**KTA-6**

**KLIPPER GUN**

**13**

**AUGUST 2015**

## PARTS ELIMINATED

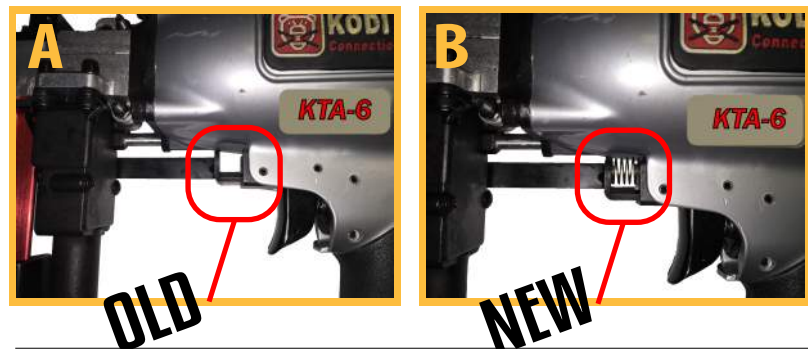
We have streamlined our Klipper Gun by redesigning one side of the Nozzle Assembly. Parts have been eliminated and the Safety Actuator Spring has been moved.

The *new* Nozzle eliminates the need for the following parts:

PART #	ITEM	QTY
70-16422	Safety Cover	1
70-A6607	Bolt	1
70-B6603	Bolt	1
70-10428	Spring	1

Included with this Service Bulletin is an updated parts breakdown and one (1) Safety Spring [PN: 70-10127]. Here is the Field Fix:

1. Install the new Nozzle [PN: 70-36421] as you would the old Nozzle [PN: 70-26421], note that you will no longer need the parts listed in the PARTS ELIMINATED box above.
2. Place the included Safety Spring [PN: 70-10127] between the flat side of the Safety Unit [PN: 70-16408] and the Safety Guide [PN: 70-10407]. [See Figures A & B]
